Development Plan Public Realm Report

DELEGATE REPORT

MINISTERIAL PLANNING REFERRAL

Application number:	TPM-2019-26
DELWP Application number:	SP070004
Applicant / Owner / Architect:	Ashe Morgan Pty Ltd / Development Victoria / NH Architecture
Address:	50-94 Waterfront Way and 2-16 Little Docklands Drive, Docklands VIC 3008
Proposal:	Addendum to the Waterfront City Outline Development Plan 2003
Cost of works:	N/A
Date received by City of Melbourne:	Original Proposal: 26 September 2019 Current Proposal: 24 March 2021
Responsible officer:	Markus Tschech, Principal Urban Planner

Figure 28 Staging Diagram

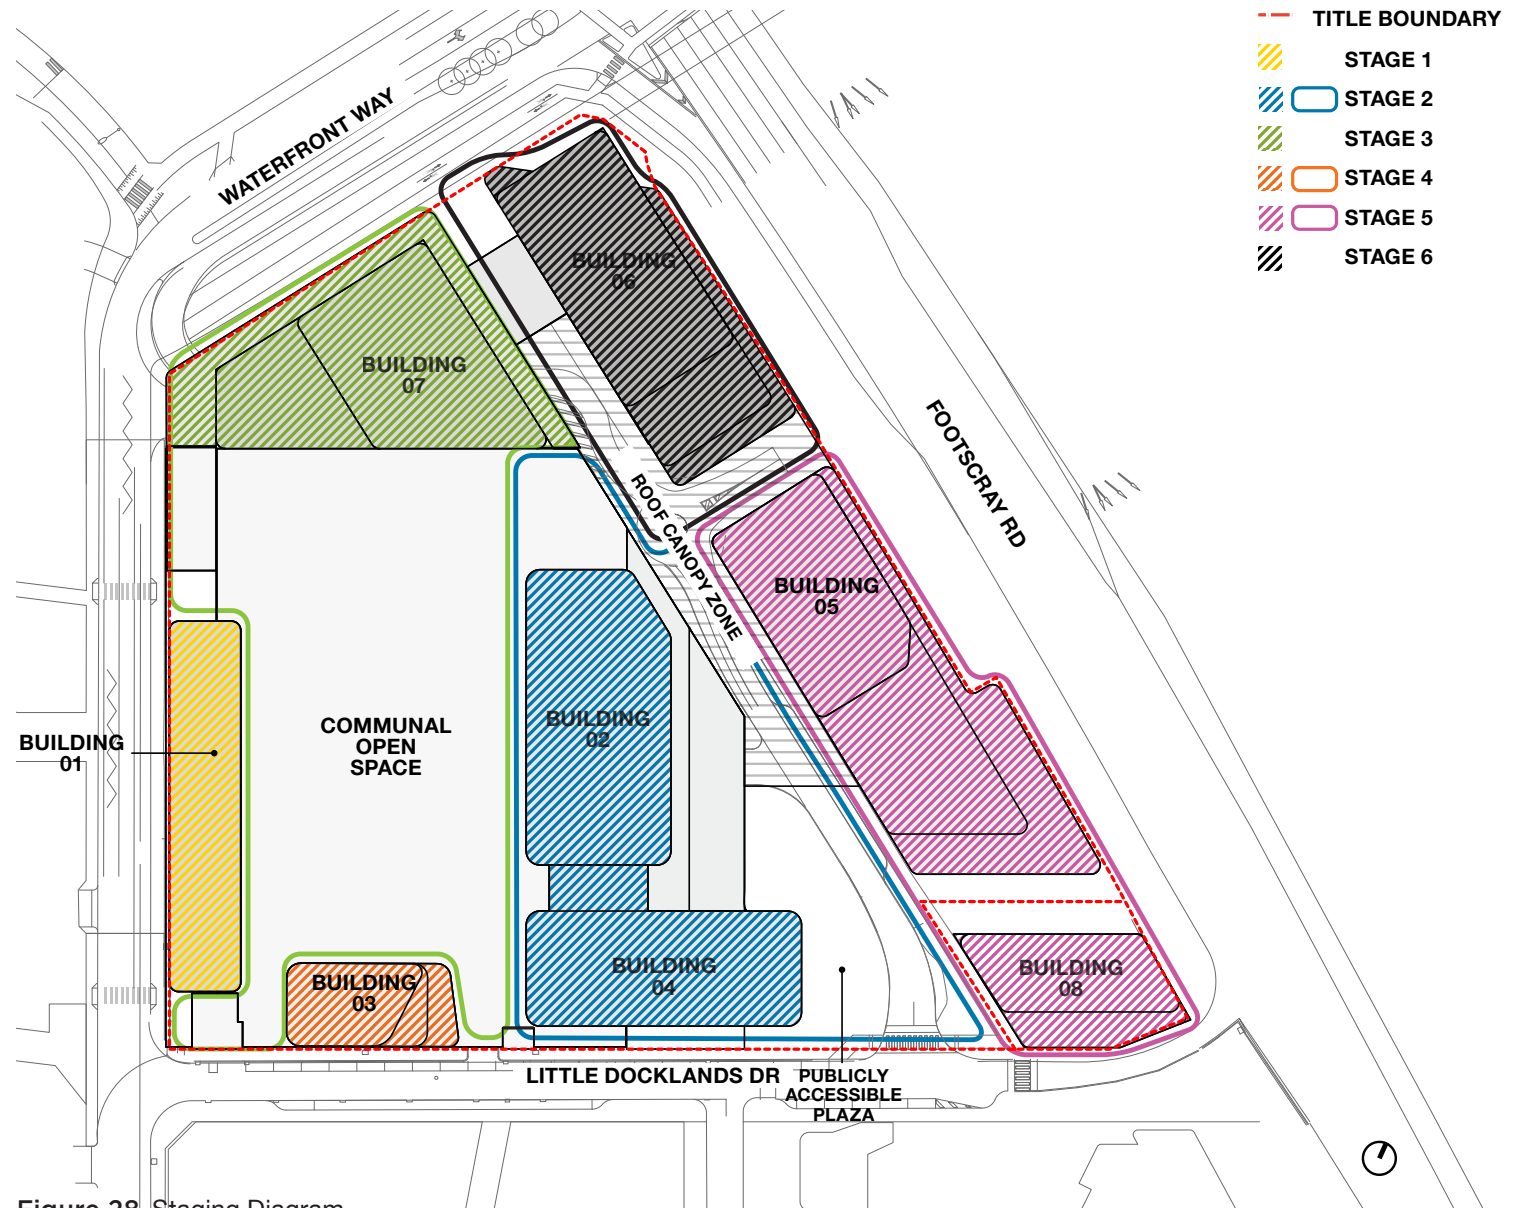
8. Figure 28 (Staging Diagram) updated to:
 - a. Adopt the same building numbers as the remainder of the DP Addendum.
 - b. Incorporate the remainder of the internal road into stage 3.

Figure 16 – DP Addendum podium heights, tower setbacks and separation

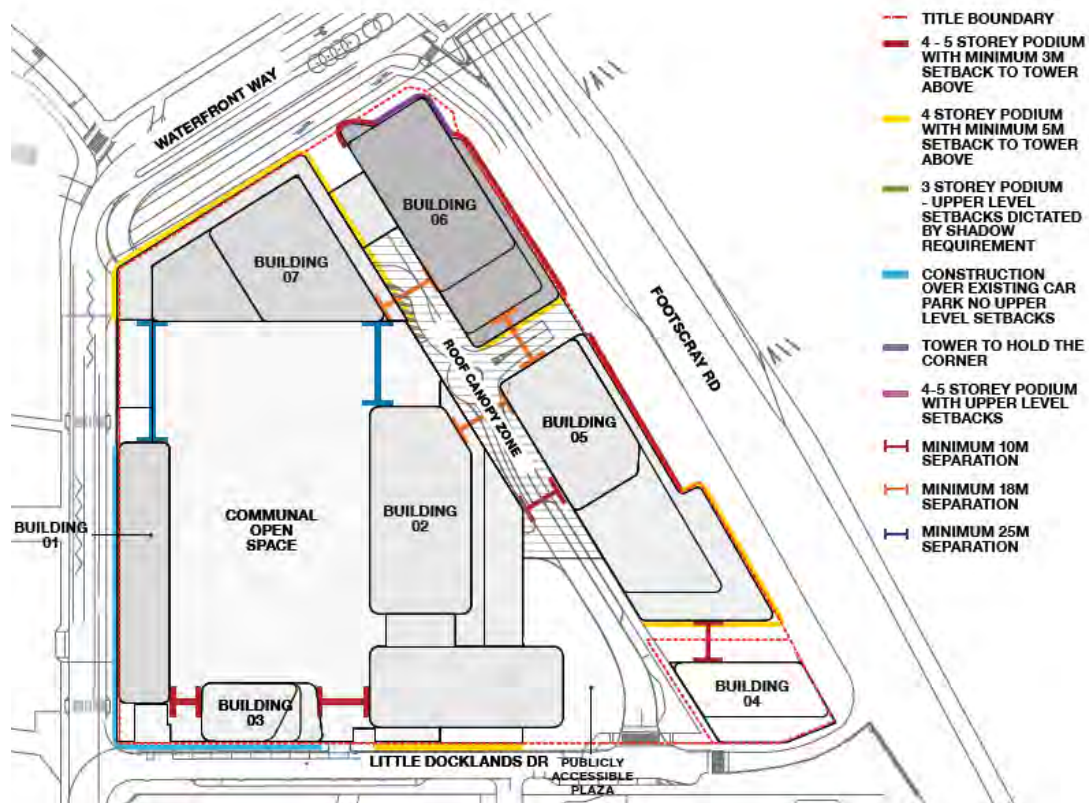
As illustrated in Figure 16, the proposed DP Addendum includes discretionary setback and building separation controls for each of the six building envelopes. In the main, the buildings would have a 4-5 storey podium with upper level setbacks of 3-5 metres. Exceptions to this include a 59 metre street wall height for Building 1 and a 90 metre street wall for a portion of Building 6. The 59 metre street wall height for Building 1 is generally consistent with the approved residential hotel on that portion of the site.

It is also noted that the diagram at Figure 16 does not include podium heights for Building 04 and the green line denoting a three storey podium is now superfluous.

This appears to be an oversight which can be resolved via a condition.

Figure 21 - DP Addendum Concept Plan 5 - Maximum heights, roof plan

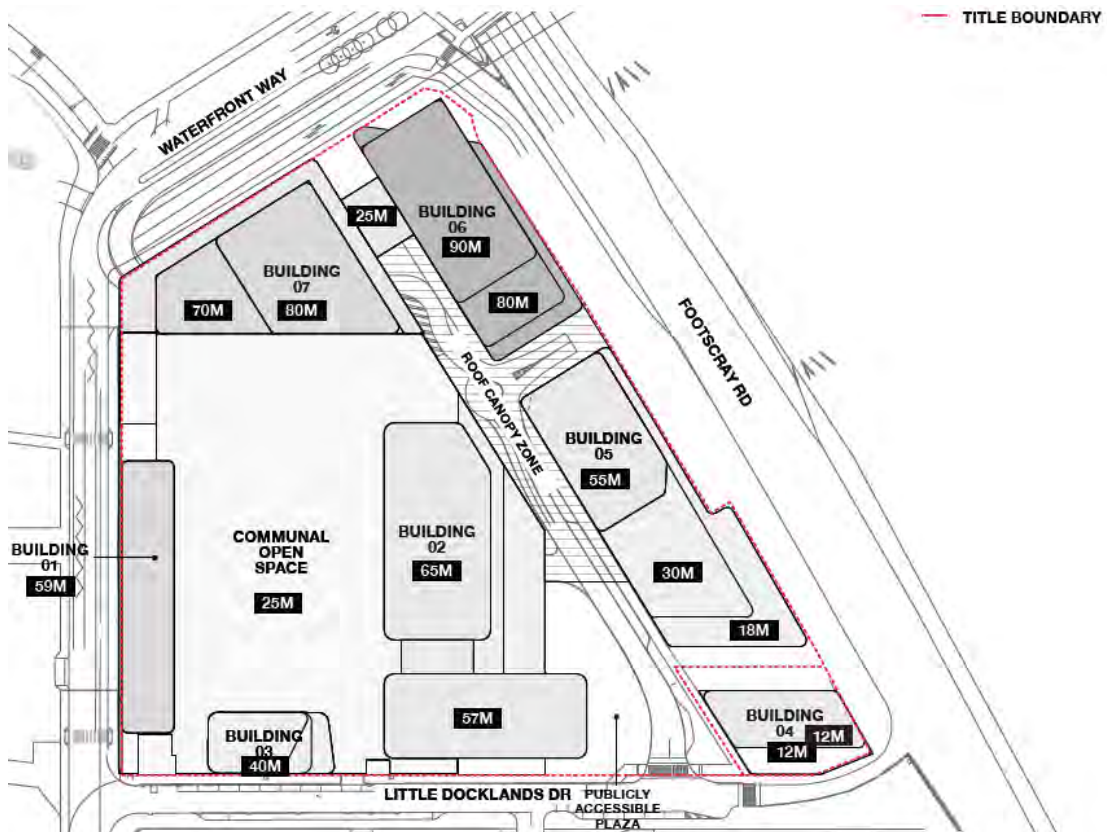
The proposed DP Addendum includes six separate buildings with maximum heights ranging from 12 metres (Building 4) to 90 metres (Building 6) as shown in Figure 22. The extent of increased building heights above the current DDO controls is therefore up to 40 metres (Building 6), with Buildings 3, 4 and the southern half of Building 5 being at or below the preferred height.

Figure 23 – Building envelopes of the original DP Addendum (left) and Proposed DP Addendum (right)

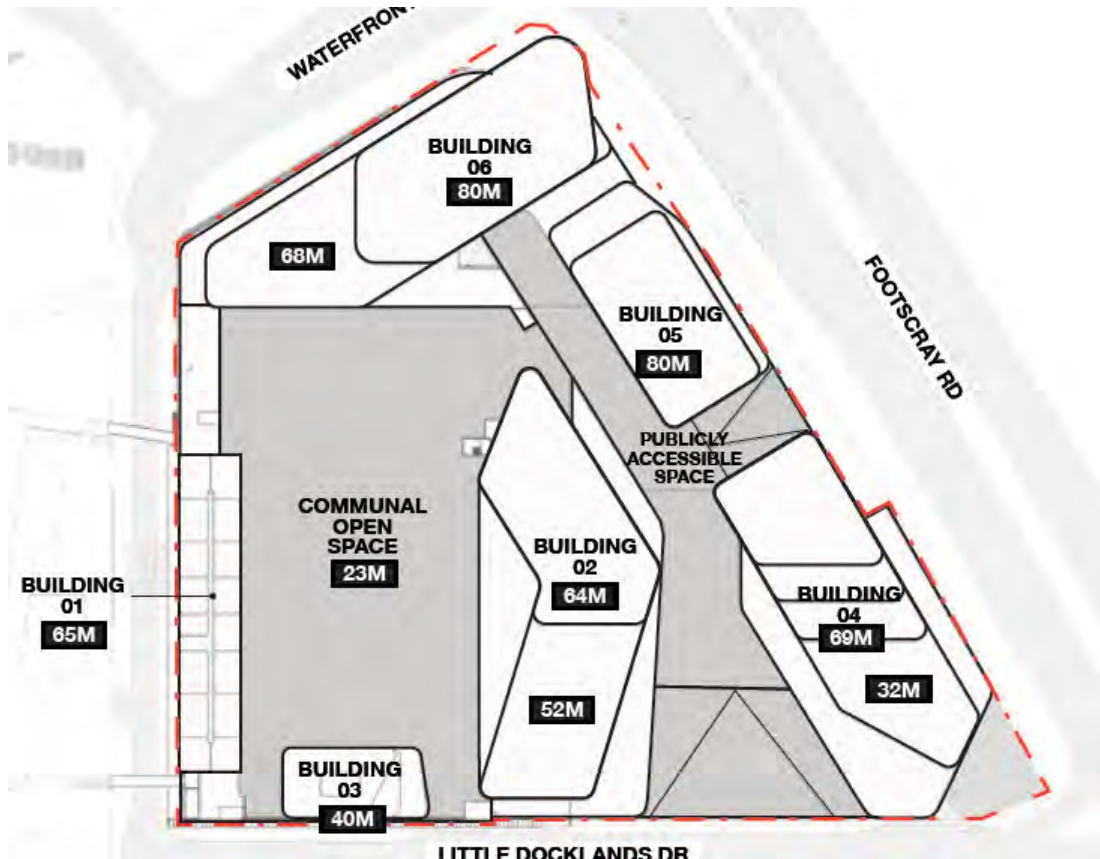
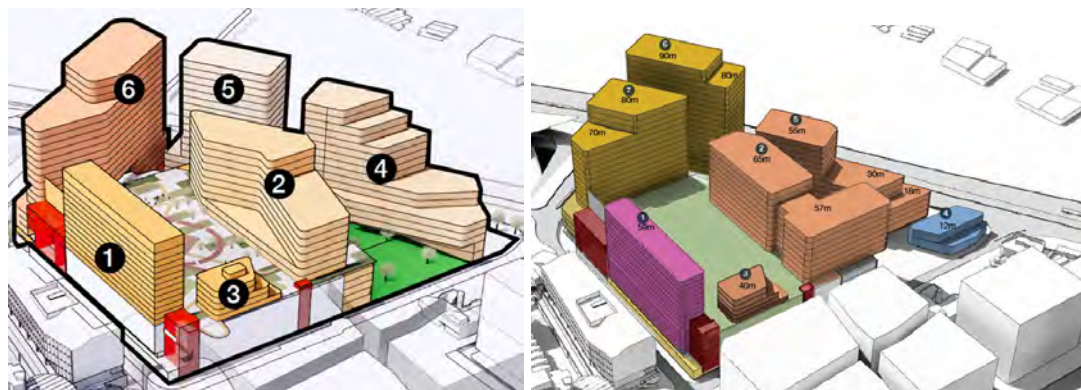
As depicted in Figure 23, the proposed heights (and envelopes) have changed somewhat since the original proposal was considered by Council, despite the overall GFA decreasing by approximately 5,000 m².

This is largely a result of the re-distribution of built form across the site, away from the eastern corner (where it is located opposite Docklands Primary School) towards the northern end of the site. The reduced heights towards the eastern corner will reduce the shadowing impacts on the school, which is discussed further at Section 9.3.3 of this report. This re-distribution is evident in the extracts at Figure 23 below and addresses another key concern of Council regarding the initial proposal.

Figure 25 - Views from Melbourne Star Observation Wheel

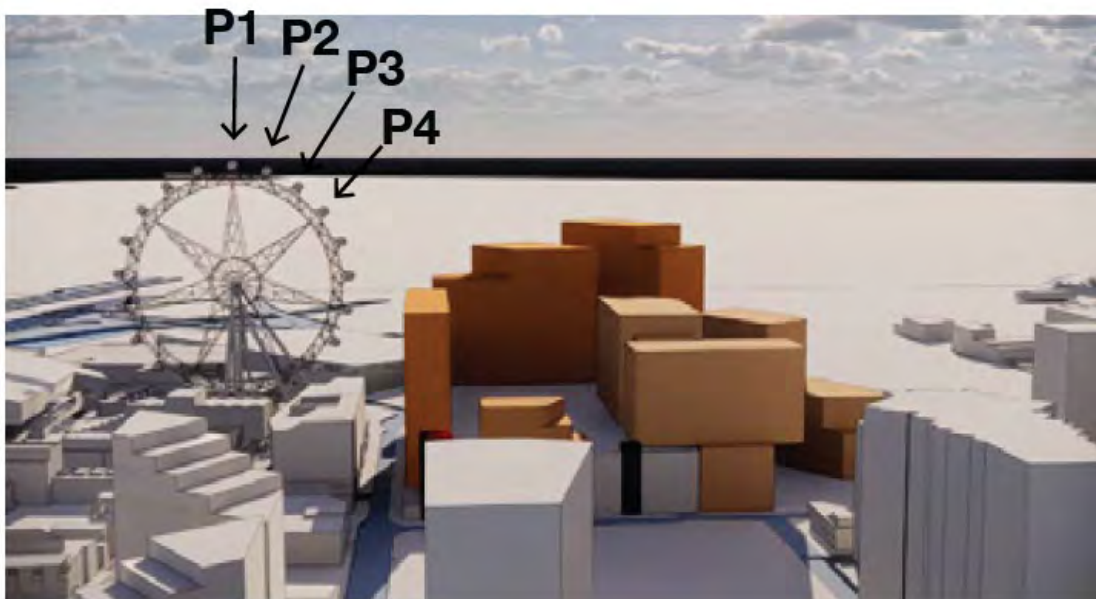
A key reason for the proposed maximum 80 metre height in the original proposal was to protect views of the Central City from the Melbourne Star Observation Wheel (refer Figure 24).

The revised height has the effect of reducing the number of 'pods' with a clear view of the city at any one time from approximately five to four, as illustrated in Figure 25. As the Melbourne Star Observation Wheel is now proposed to be removed, the site's relationship to the structure is no longer a critical factor, so long as its removal can be confirmed.

Figure 26 - Concept Plan 7 - podium heights, tower setbacks and separation

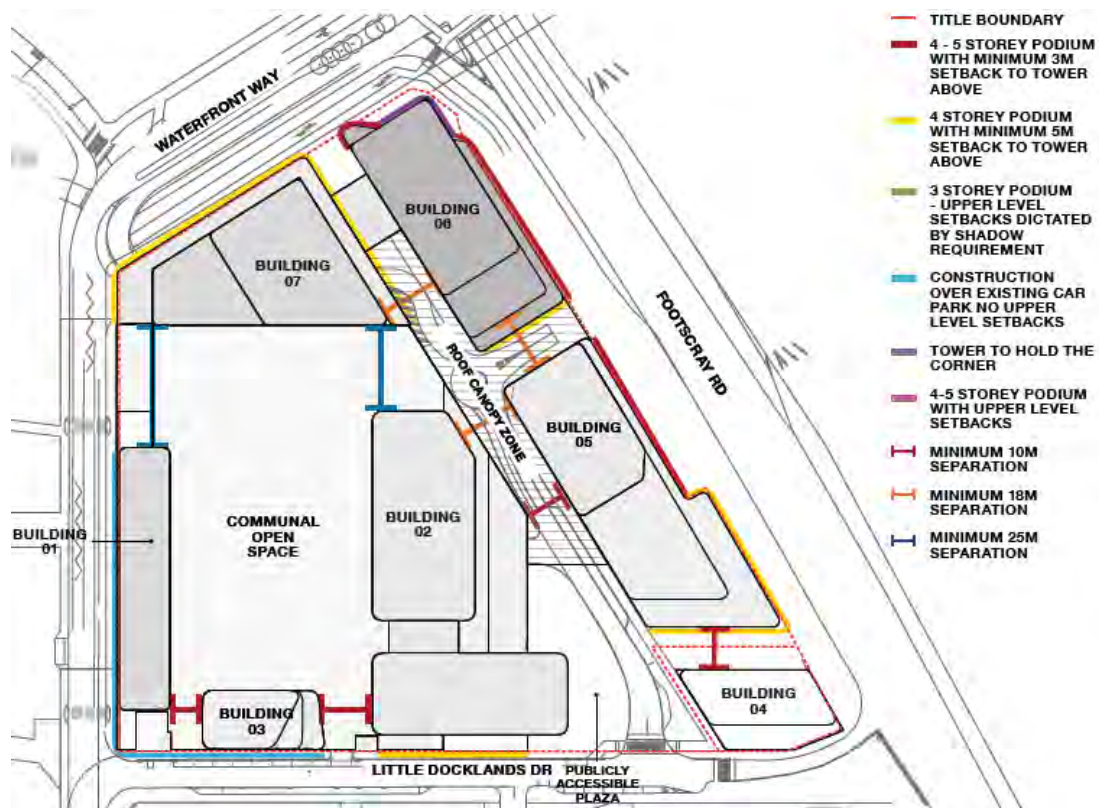
Setbacks to the internal publicly accessible spaces are also limited in the DP Addendum graphic (refer to Figure 26) with many at zero metres, and although some stepped forms are shown, these are indicative without any measurements to confirm them. In general terms, the DP Addendum graphics indicate quite specific forms which may be misleading as there are no measurable controls to support them.

Experience elsewhere, including the Hoddle Grid and Southbank, where setbacks were subject to close scrutiny in the formulation of Planning Scheme Amendment C270 and its associated DDO10 is that a mandatory minimum setback to provide both a visual break and to deflect wind down drafts is five metres (noting that the preferred setback remains at a more generous 10 metres). There is no good reason to differ from this practice at Waterfront City East, particularly given the exposed nature of the site.

Figure 27 - Concept Plan 3 – Ground Flor Public Realm Activation

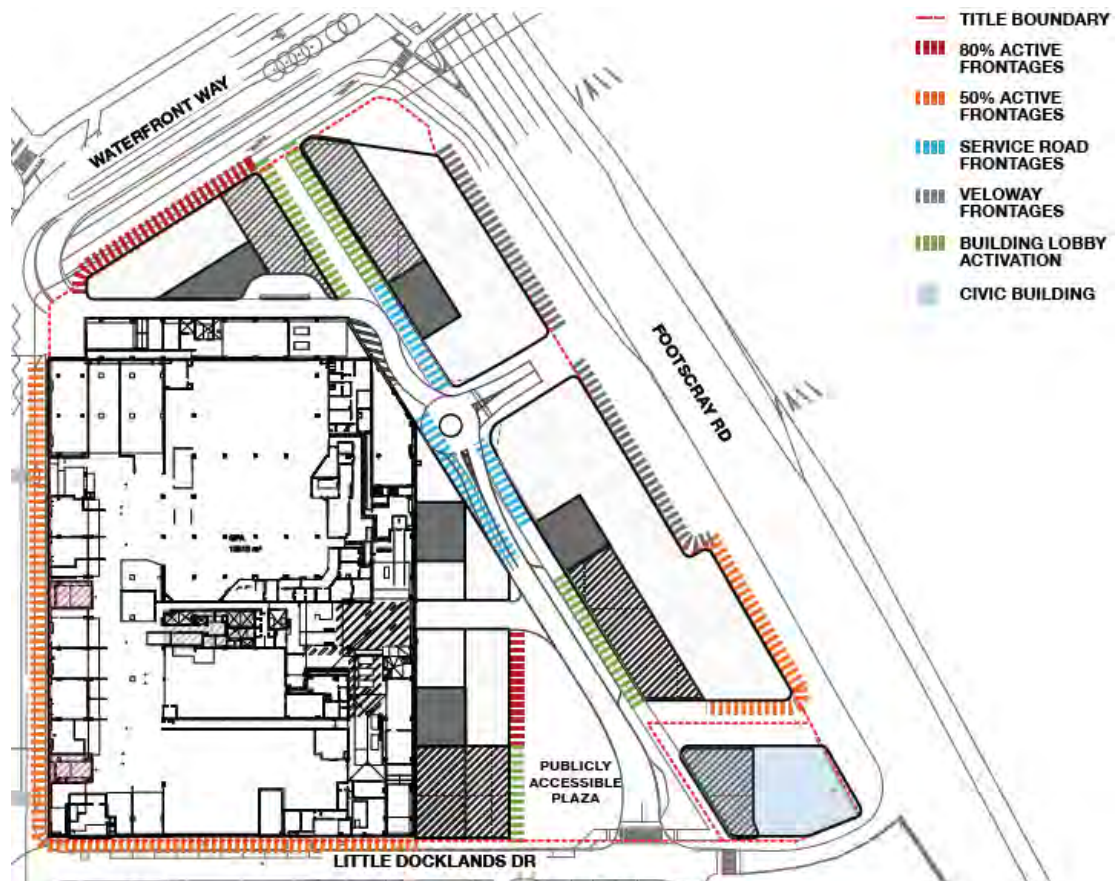
The Development Plan proposes surrounding street frontage activation of eighty per cent at the ground level of Building 7 and adjacent to the public plaza, fifty per cent to the refurbished car park and the eastern half of building 5, a combination of 'Building Lobby Entry' and service road frontage to the internal road and 'Veloway Frontage' along the remainder of Footscray Road.

Figure 28 - Concept Plan 4 - Ground Floor Public Realm Activation from the original proposal

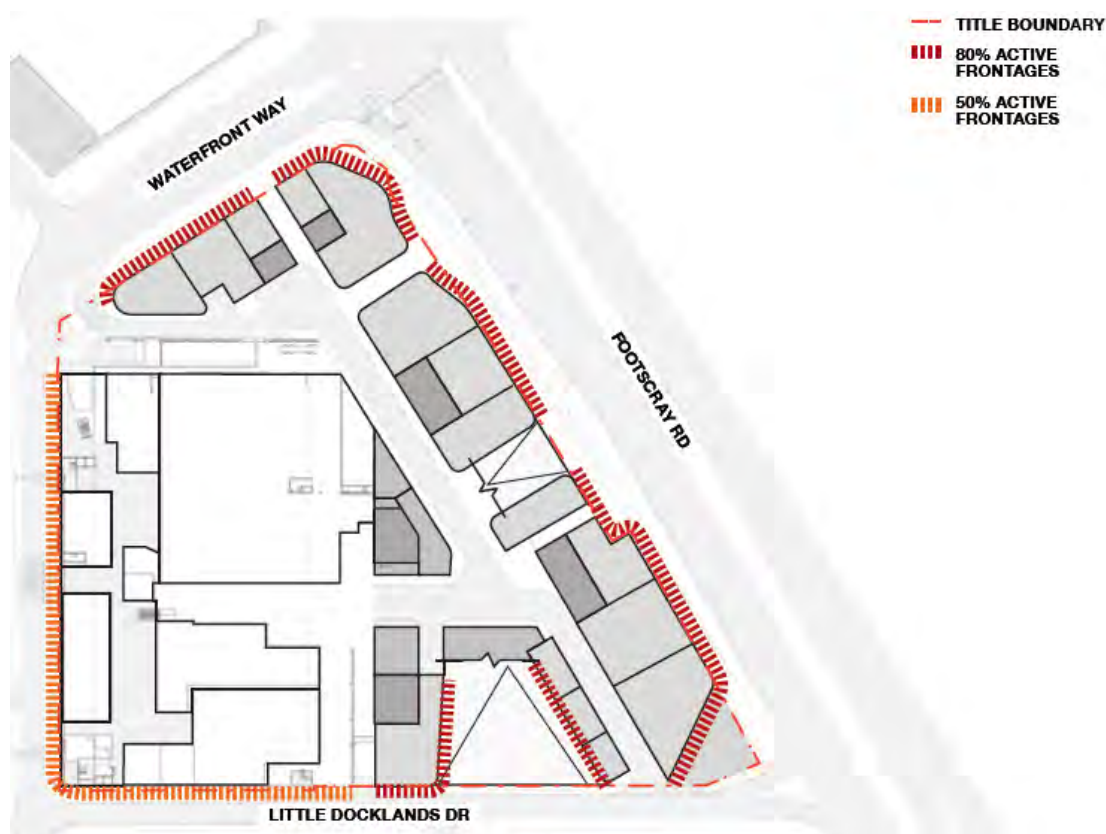
Overall, this is a considerable reduction from the original proposal, which set an active frontage of fifty per cent to the refurbished carpark, and eighty per cent to the remaining frontages (refer to Figure 28).

Figure 29 - Public Realm Plan 2

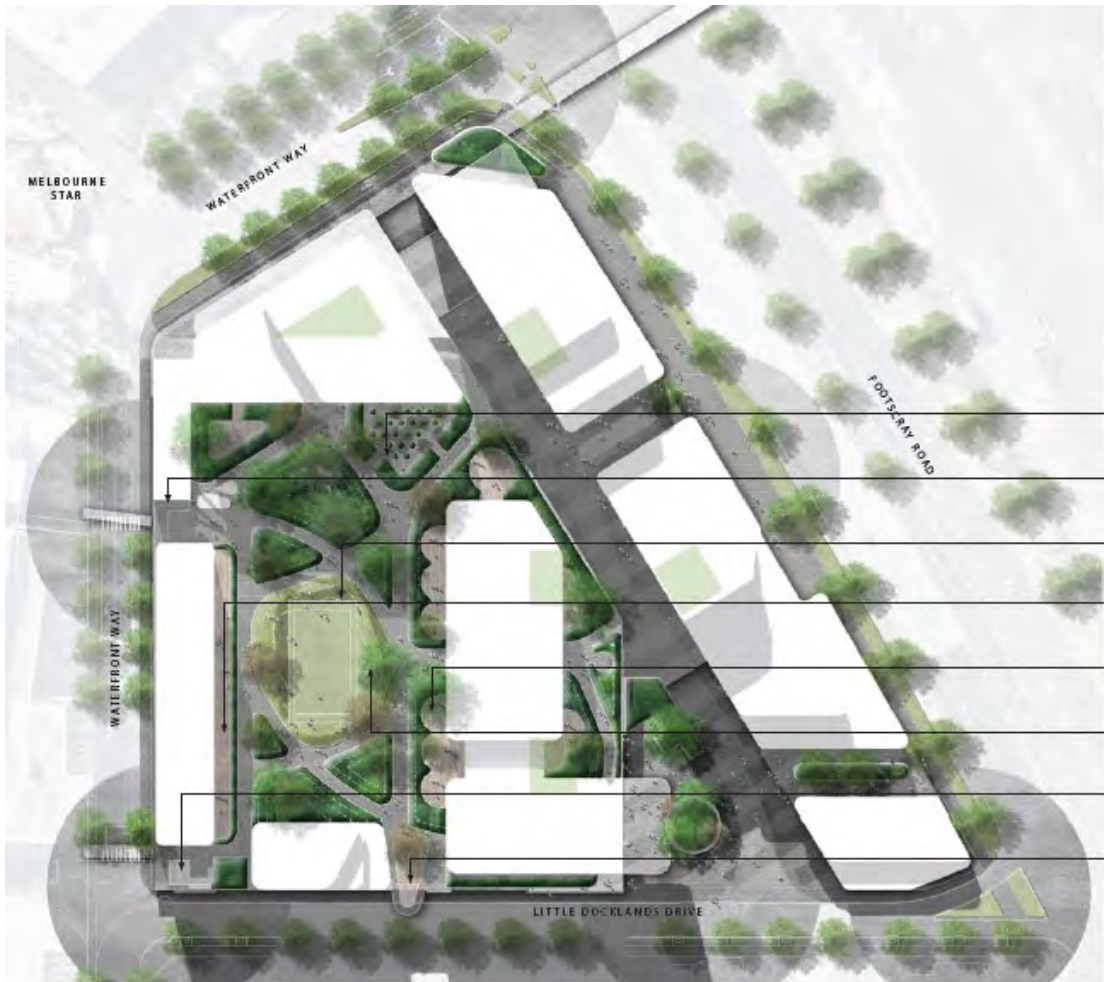
They propose general concepts, planting schedules and benchmark images for a series of spaces. In contrast to the original proposal, the planting in the plaza would have access to deep soil, as opposed to being located on a ramp above an at-grade carpark (refer to Figure 30).

Following a review of the Public Realm Plans, Council's City Design Studio has advised that the level of detail and landscape design objectives are acceptable, noting that a complete set of detailed landscape plans will need to accompany applications for each stage of the development.
